SUBJECT: Review Comments on the Crandon Mining Company Groundwater Flow Model,
Dated August 1996: Model Input - Unconsolidated Glacial Geology

Re: Verification of Model Input Data Representing Unconsolidated Glacial Deposits in the Crandon Mining Company's Ground-Water Flow Model.

Verification of Model Input Data Representing Unconsolidated Glacial Deposits in the Crandon Mining Company's Ground-Water Flow Model

Figure 1 GW Vistas cross section along row 11 showing Layer 2 pinchout and thickness of Layer 4.

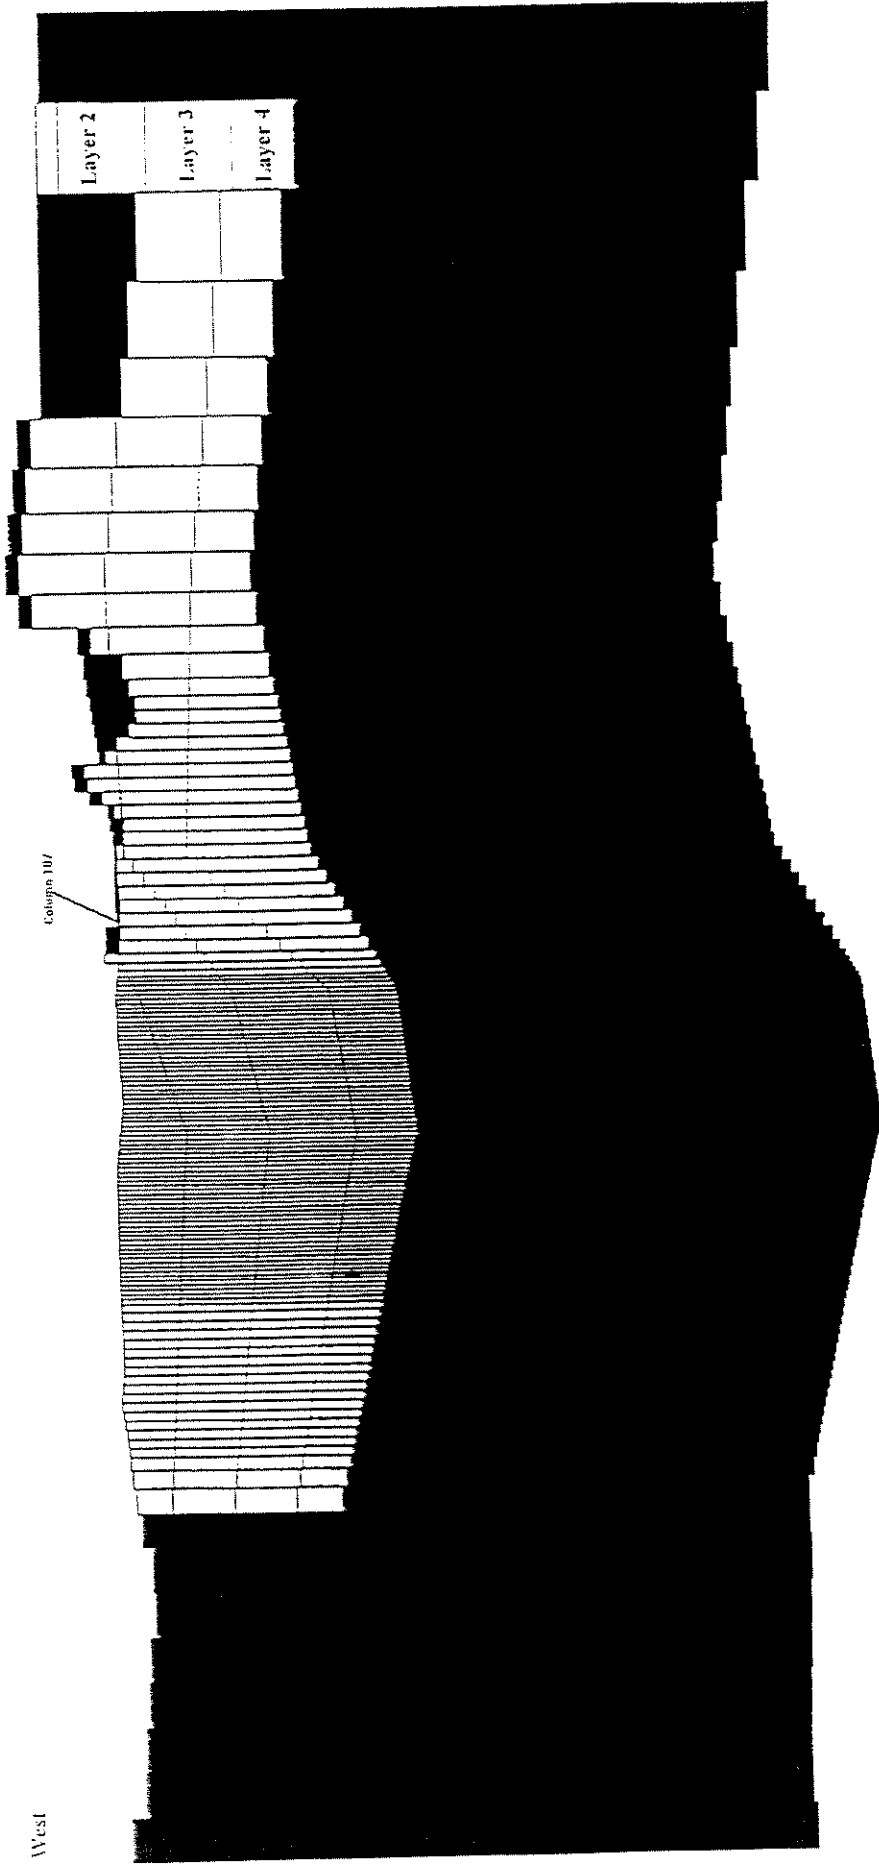
- The EIR narrative states that the thickness of Layers 2 and 3 are to be equal. Examples of cells where the thickness of Layer 2 does not equal the thickness of Layer 3 are listed in Table 2, and Figures 1, 2, 3 and 11.

- Layer 2 is absent in an area along Swamp Creek in the north-central portion of the model. As a result, these cells go dry on the first iteration of a model run and appear to behave as inactive cells.

- Layer 4 is extremely thick in the north-central portion of the model. This thick zone trends from just north of Swamp Creek to an area between Lakes Metonga and Lucerne. This thick zone does not conform to the relative thicknesses of layers described in the EIR to be applied outside the area defined by the cross sections, and could influence water movement in the model.

Figure 2 GW Vistas cross section along row 15 showing relative thicknesses of Layers 2, 3 and 4

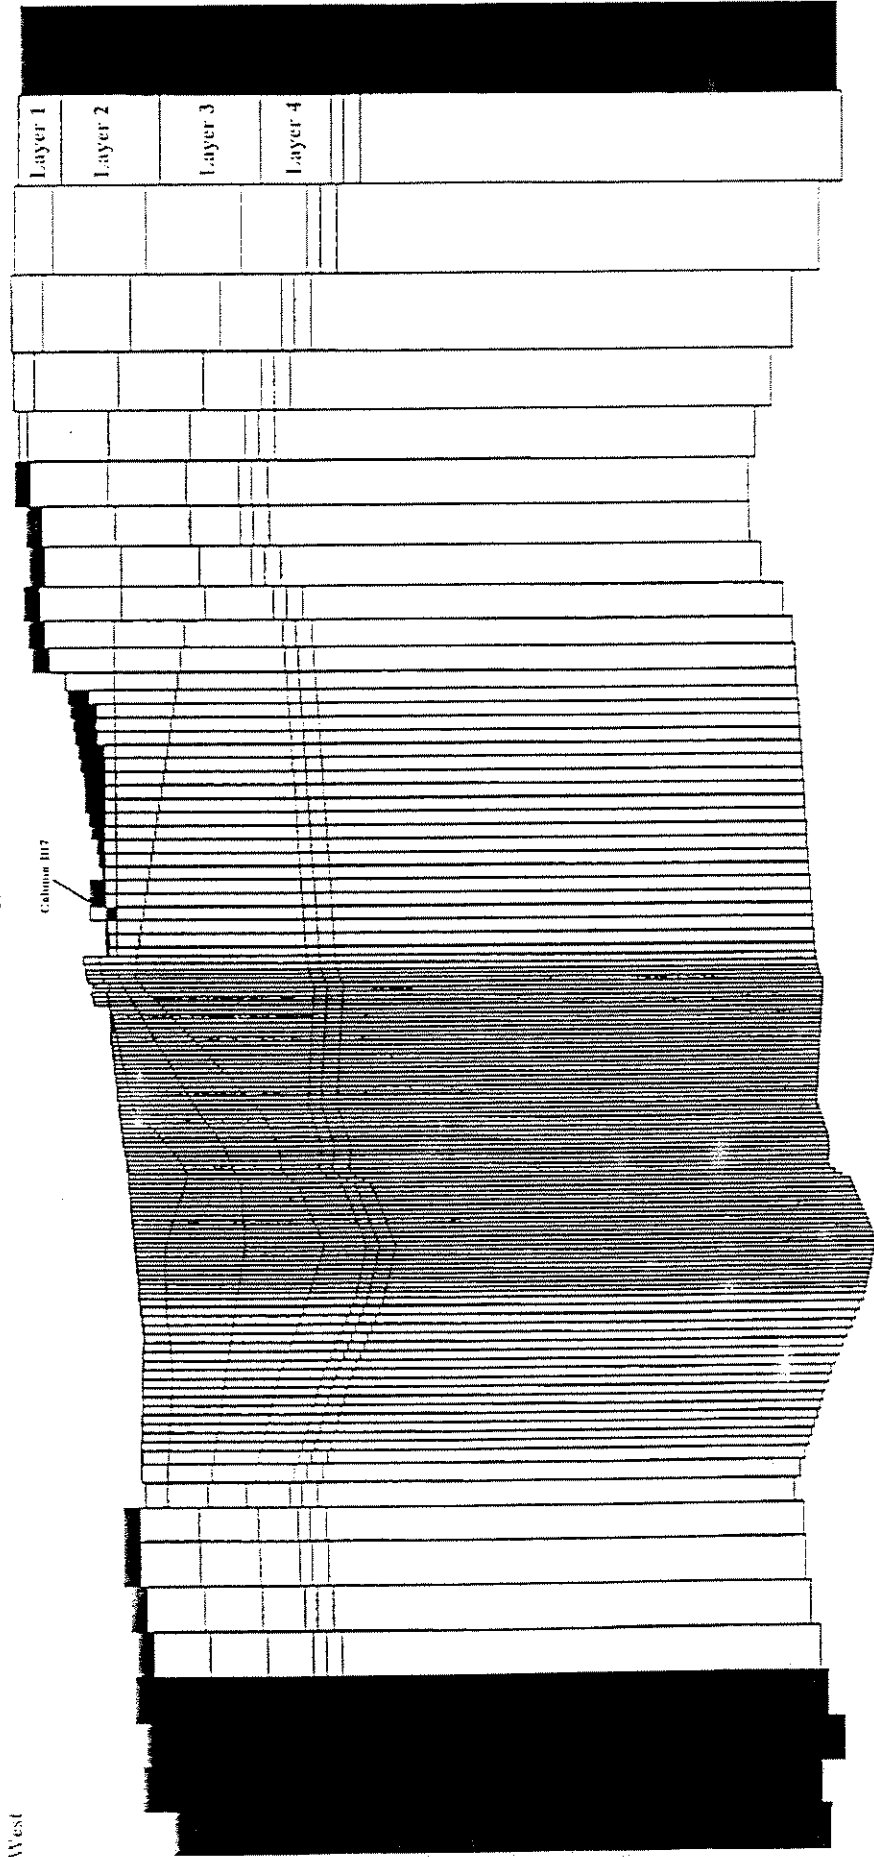
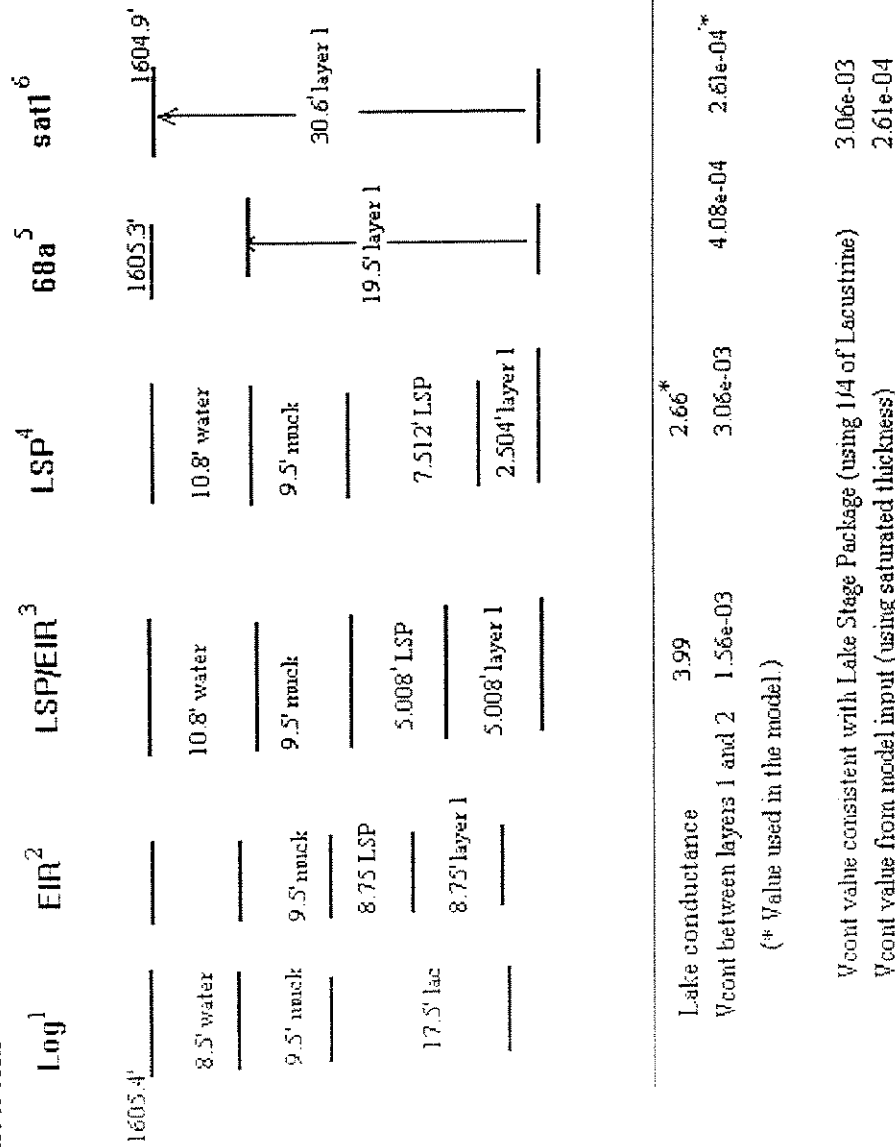
- Outside the area defined by the cross sections, model Layers 1 through 4 do not consistently show relative thicknesses of 7, 35, 35 and 23 percent. Examples of significant deviations from these percentages are presented in Figures 1, 2 and 3. Layer thicknesses outside the area defined by the cross sections may have an effect on the base flow to Swamp Creek.

Figure 5 Various thicknesses used to represent Layer 1 at well STS DL-1
(Row 98, Column 92)

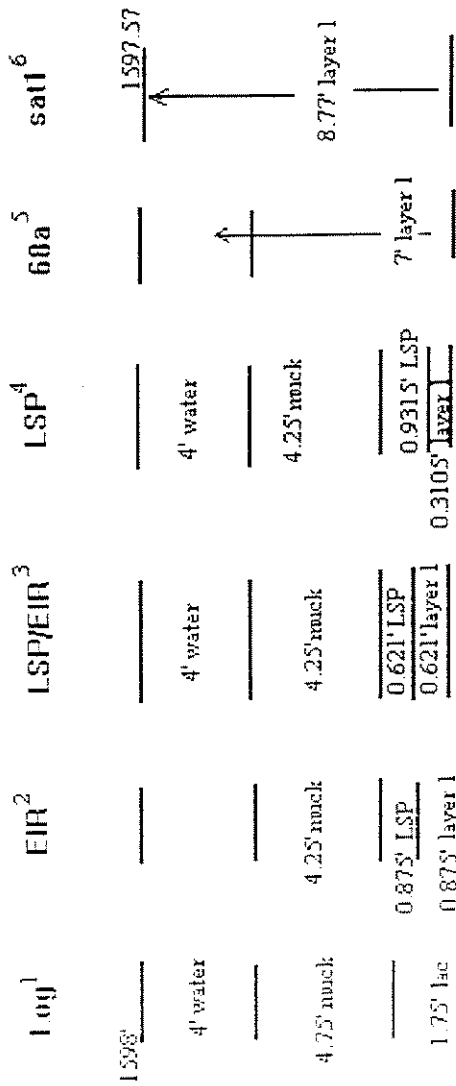
- The LSP input uses $\frac{3}{4}$ of the total thickness of lake sediments for calculating vertical conductance rather than $\frac{1}{2}$ the thickness as described in the EIR. As a result, only $\frac{1}{4}$ of lake sediment thickness remains to be incorporated into model Layer 1. This is not consistent with either the EIR model narrative or what is generally presented on model cross sections.

- Model input for Layer 1 thickness appears to be calculated from the top of the muck to the bottom of the lake sediment. This thickness is much greater than the $\frac{1}{2}$ lake sediment thickness (consistent with EIR) or $\frac{1}{4}$ lake sediment thickness (consistent with LSP). As a result, the calculation of horizontal flow in Layer 1 could be affected.

- VCONT between Layers 1 and 2 is calculated using a saturated thickness of Layer 1 which is measured from the lake-water surface to the bottom of the lake sediments. This thickness is much greater than $\frac{1}{2}$ (consistent with EIR) or $\frac{1}{4}$ (consistent with LSP input) of the lake sediment. As a result, the VCONT calculated for model input is roughly one order of magnitude lower than VCONT calculated using $\frac{1}{4}$ of the lake sediment thickness.

- The various thicknesses used to represent Layer 1 under the interior lakes are presented in Figures 4 through 10.

Figure 11 the GW Vistas cross sections illustrating thickness differences between Layers 2 and 3 beneath the internal lakes.

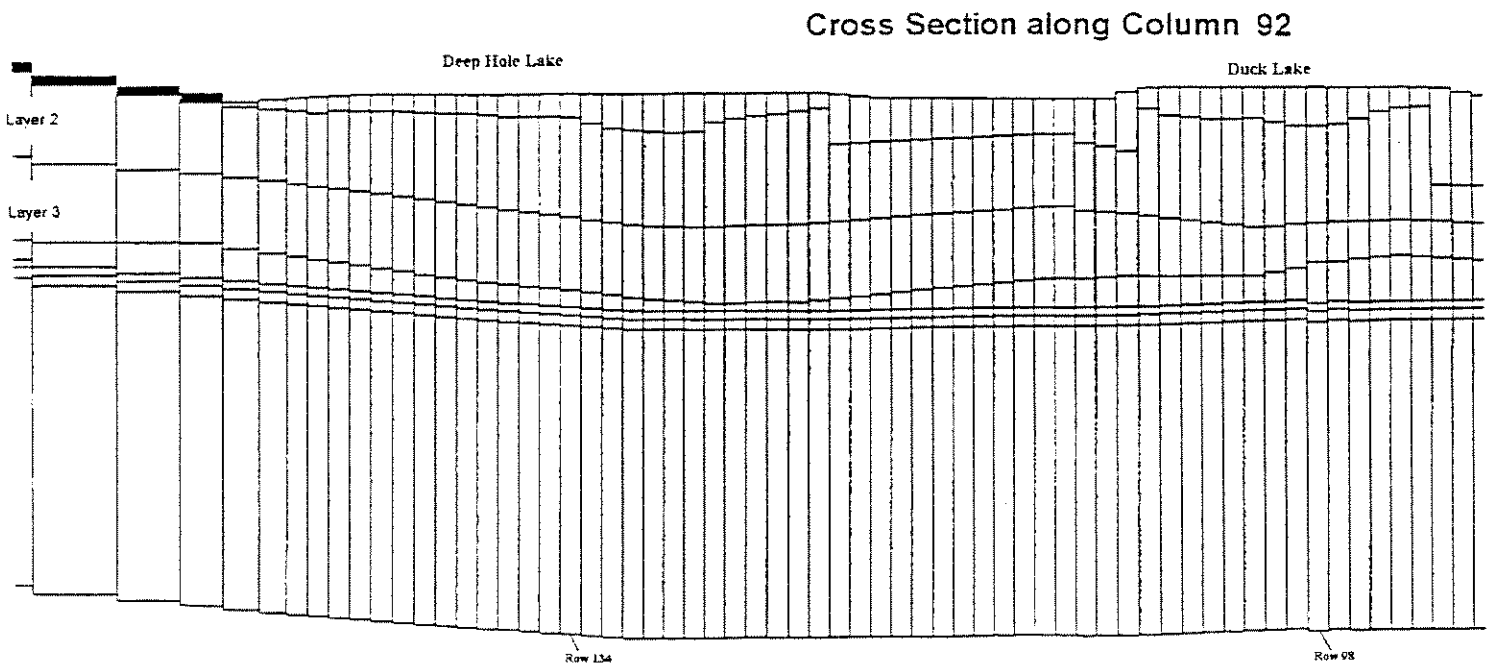
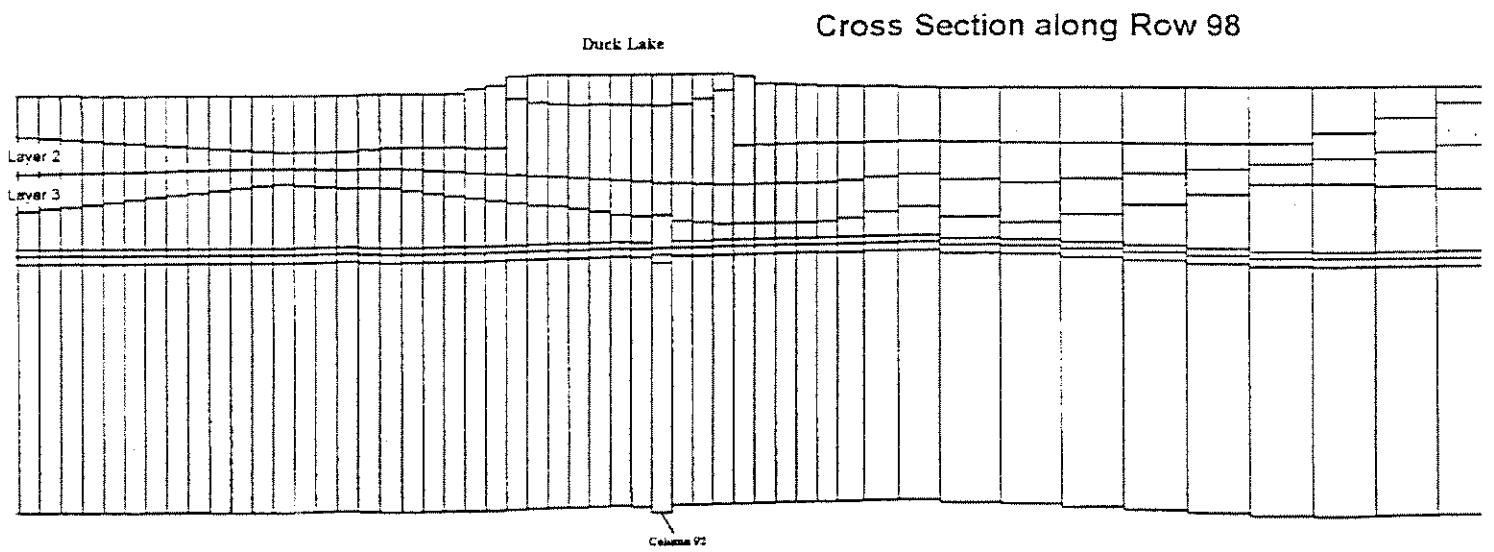
Layers 2 and 3 - The thickness of Layer 2 does not equal the thickness of Layer 3 under the internal lakes - particularly under Deep Hole and Duck Lakes.

- It appears that the position of the Layer 2/Layer 3 boundary was not adjusted following the assignment of the bottom of Layer 1 to the bottom of the lake deposit. It may be CMC's intention to handle layers under the lake this way, but this treatment of the layers was not described in the EIR model narrative, nor were the possible effects on the flow model in the vicinity of the lakes discussed.
- Examples of cells under lakes where the thickness of Layer 2 does not equal the thickness of Layer 3 are listed in Table 2, as well as cross sections from GWVistas presented on Figure 11.

Figure 12
Distribution of model input values for Kh in Layer 1

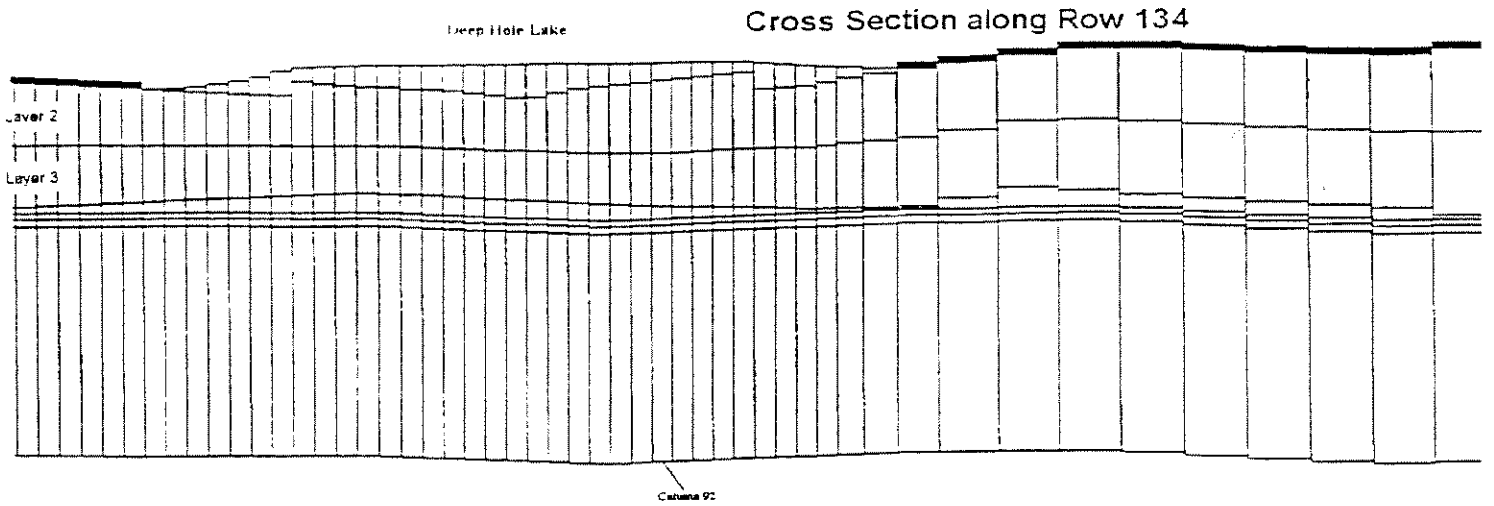
- Most cells in Layer 1 have values consistent with the assigned Late Wisconsin till value (0.8 feet/day). However, several broad (non-lake) areas in the interior portion of the model have values less than 0.8 feet/day. Table 5 contains examples of Kh values in Layer 1 that are less than 0.8 feet per day. Figure 12 shows Layer 1 Kh values in the interior portion of the model. In Figure 12 a different shade of gray represents each Kh value assigned to an input parameter (0.8 feet/day for Late Wisconsin till, 7.3 feet/day for coarse outwash, etc.). Model input values which fall in between two set parameter values were assigned a median value and an intermediate shade of gray (4.05 feet/day assigned to all values between 0.8 and 7.3 feet/day). Even though most of the lower Kh values occur in inactive cells, a significant number do occur in active cells. Kh values less than 0.8 feet/day can perhaps be explained for cells immediately adjacent to lakes with Kh values of 0.008 feet/day, but cannot be explained for other cells which are located away from the lakes. Layer 1 Kh values significantly lower than 0.8 feet/day may affect horizontal flow in those areas of the model.

Figure 15 Hydraulic Conductivity Zones for Layer 4

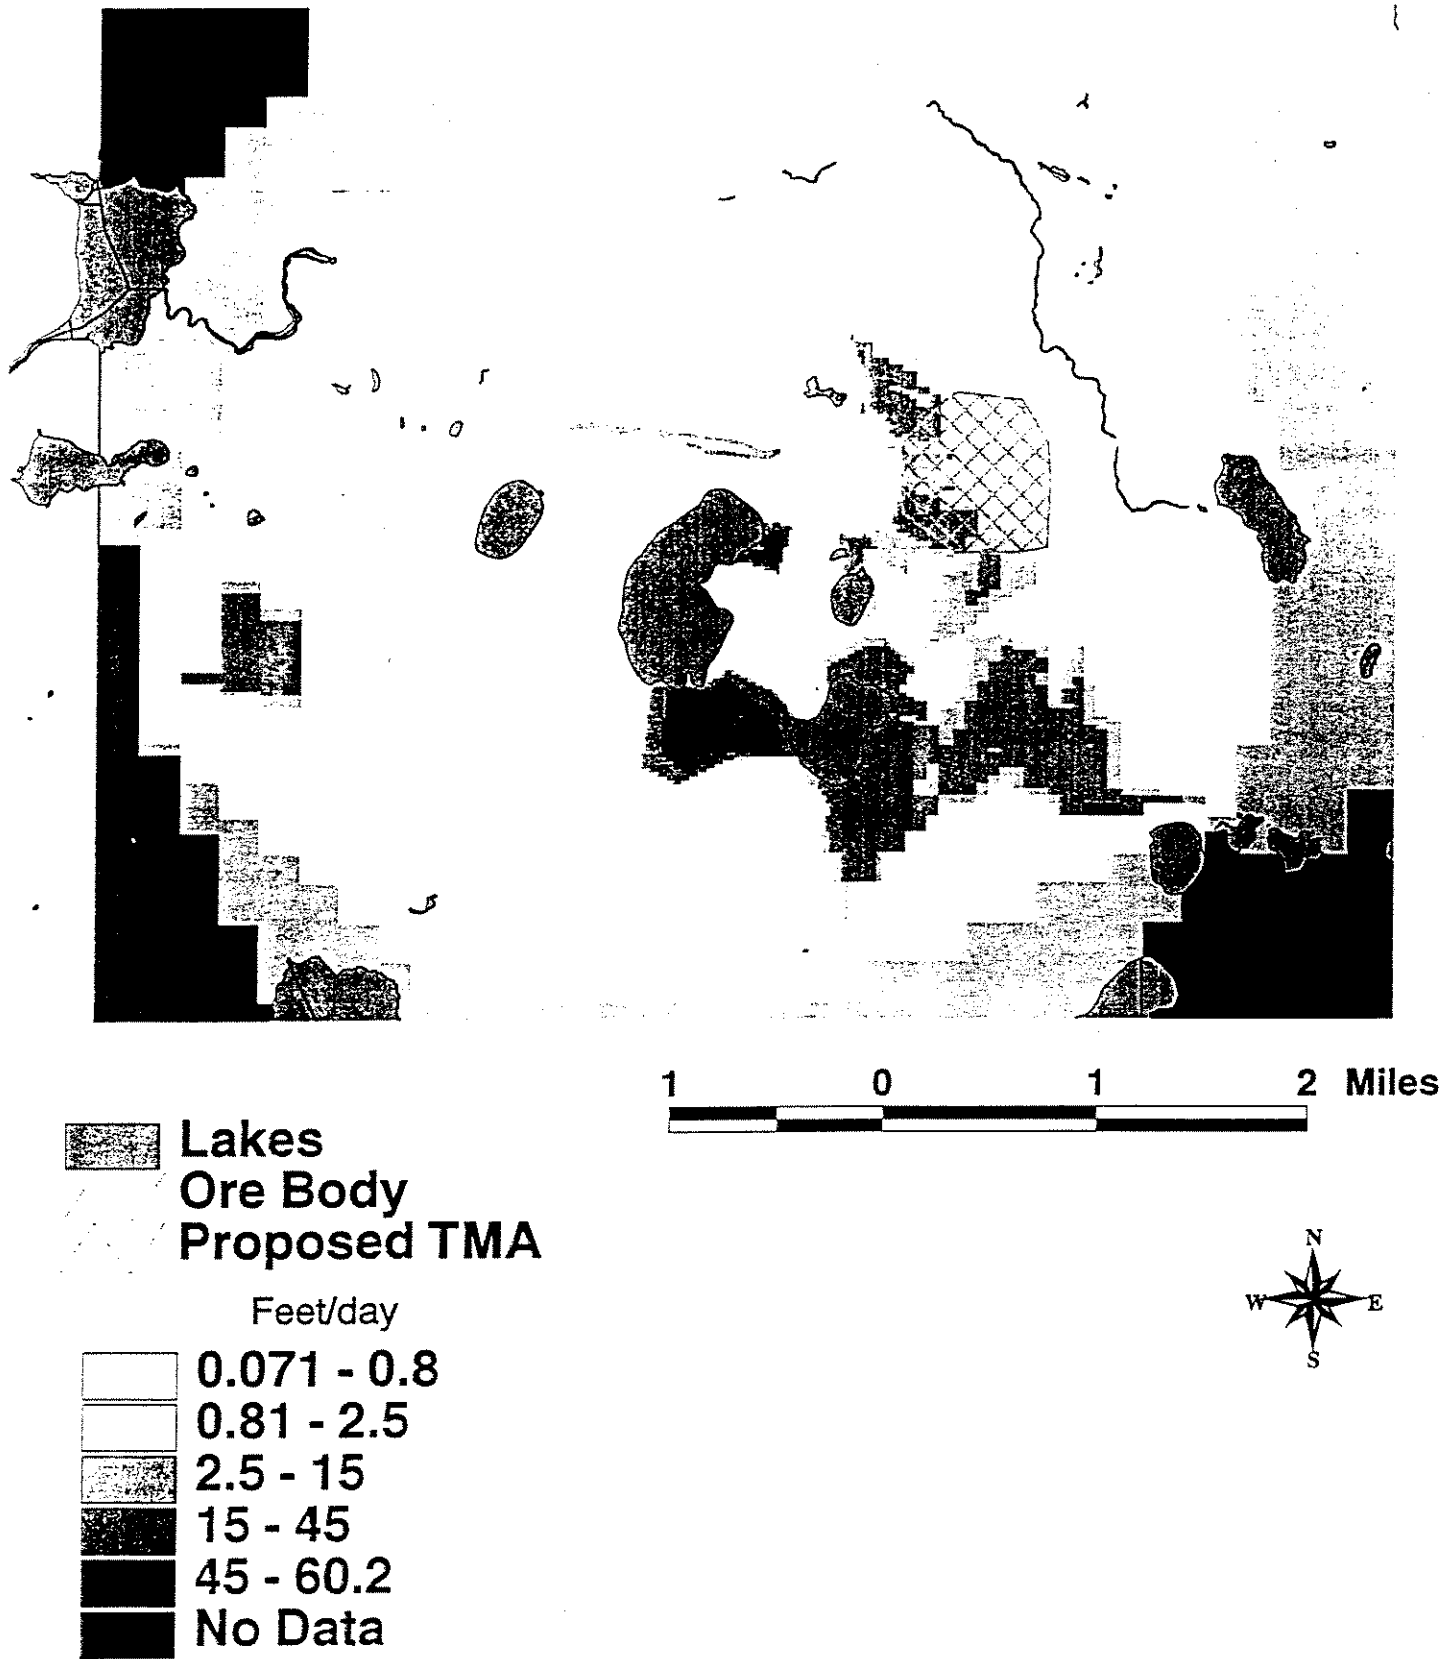
- Layer 4 includes some areas of Kh which are significantly higher or lower than expected for Early Wisconsin till (0.8 feet/day). Areas are found with Kh values as low as 0.071 feet/day, and as high as

43 feet/day. These areas are concentrated around the interior lakes and under the TMA (Figures 15 and 16). The input value for Layer 4 conductivity is significant because of its influence on the movement of water between the glacial sediments and the bedrock in the model.
